Conservation Consultancy Advice:

453	Case ref. no:	Y18/1335/FH and Y18/1336/FH
Property Address:	Barling House, Clubbs Lane, Brookland, Romney Marsh	
Proposals:	Erection of a replacement porch to north-east elevation, erection of a Single storey extension to north-west elevation, removal of chimney Stack at ground floor and replacement of existing back door with window, installation of new doorway through to new extension and removal of internal wall to create new utility and WC	
Application Type	Planning Permission and Listed Building Consent	
Agent:		
General Comments Operative Conditions?		
Listing / C/A?	Grade II	
Date Consult Received:	24/10/2018	
Date Comments Sent:	04.12.2018

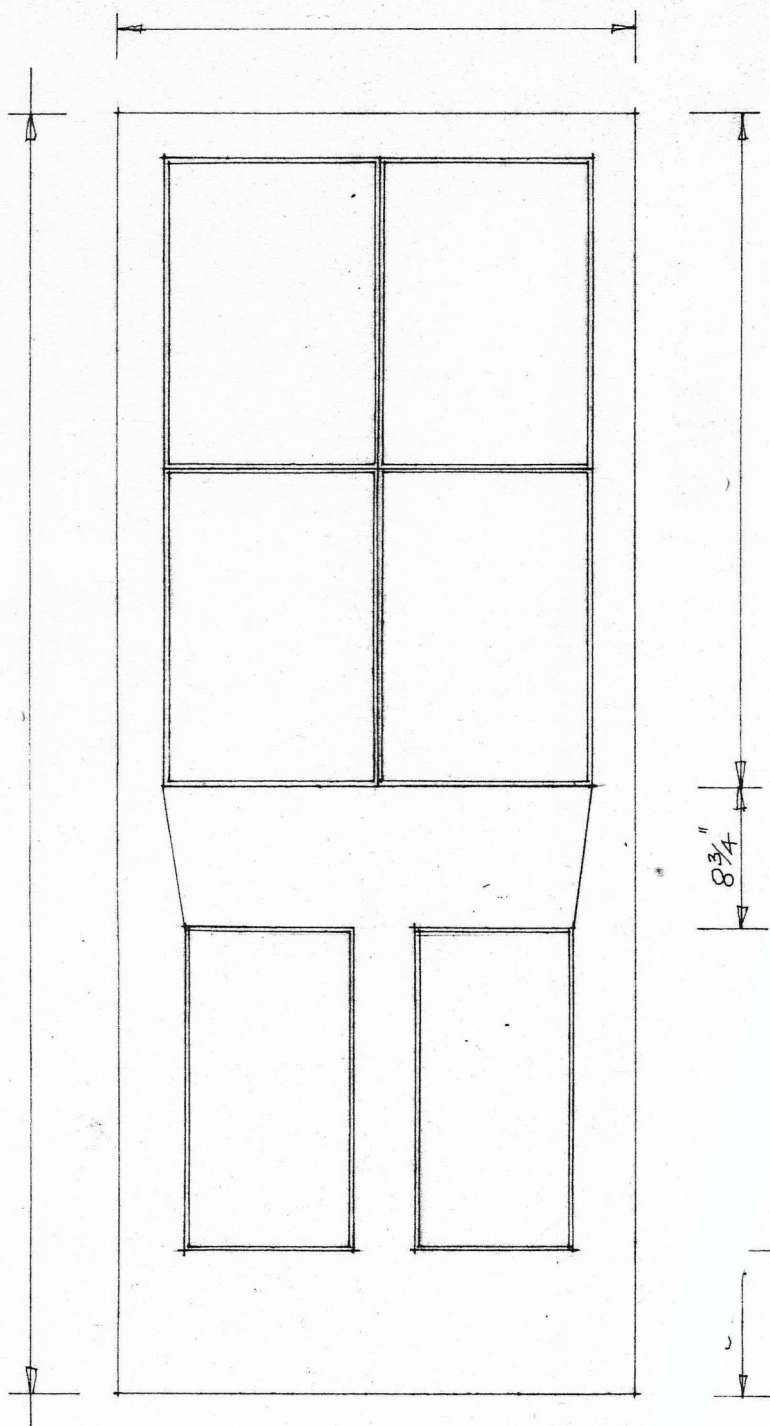
The proposed replacement seems however to be a bit too large scaled and would benefit to being reduced down to say a 1.5m projection, omitting the brick built sections at the back. The hipped roof design is ok but the eaves need to follow round at the front the same level as the sides, not higher over the door as shown.

The design needs to be carefully detailed with a more traditional door design and with smaller narrower casements, more in scale with the existing. These should have glazing bars but one horizontal bar only would do, more akin to the existing porch windows.

The brick plinth should be built Flemish bond with the window joinery extending back to abut the house without any brickwork above cill level.

The proposals would need to be presented at a scale of 1:50.

ELEVATION SCALE 1:

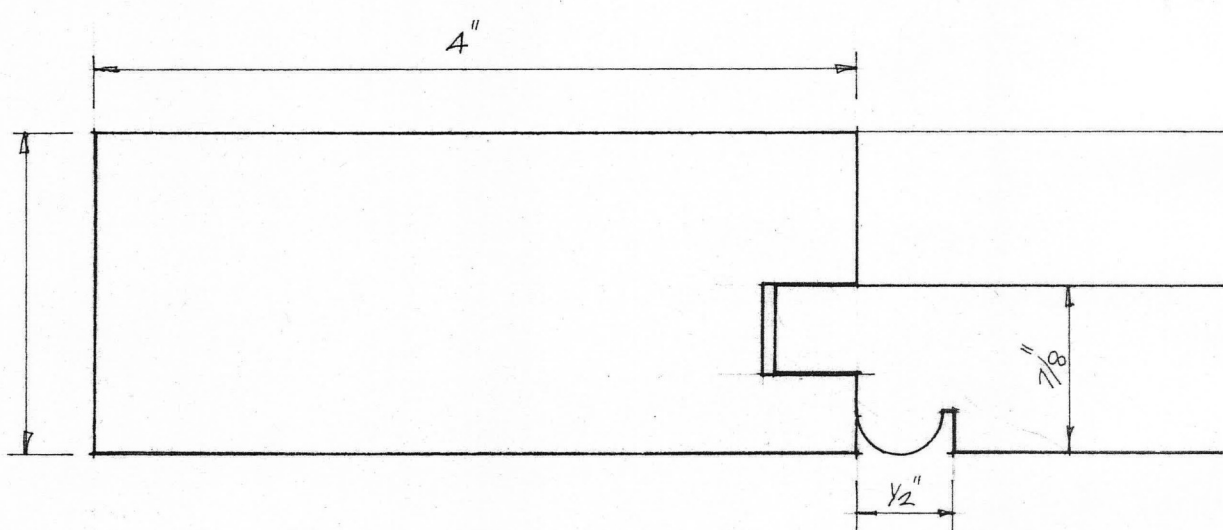
glass sill line level with glass line on adj window
